CERTIFICATE OF APPROPRIATENESS

Property: 501 Heights Boulevard, lot 12, block 291, Houston Heights Subdivision. The property includes a historic 1,689 square foot, one-story wood frame single-family residence situated on a 5,900 square foot (50' x 118') corner lot.

Proposal: Alteration – Construct a one-story 711 square foot addition to the rear of an existing one story 1,689 square foot contributing residence.

Recommendation: Approval

FRONT DOOR

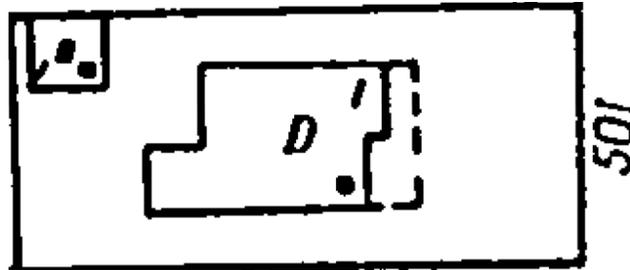
CC: NOT ORIGINAL – FRONT DOOR TO BE REPLACED WITH NEW JELD-WEN AUTHENTIC WOOD GLASS PANEL EXTERIOR DOOR WITH CRAFTSMAN SHELF DETAIL(6203 SHELF). EXISTING DOOR IS NOT ORIGINAL AND THE STYLE IS NOT APPROPRIATE.
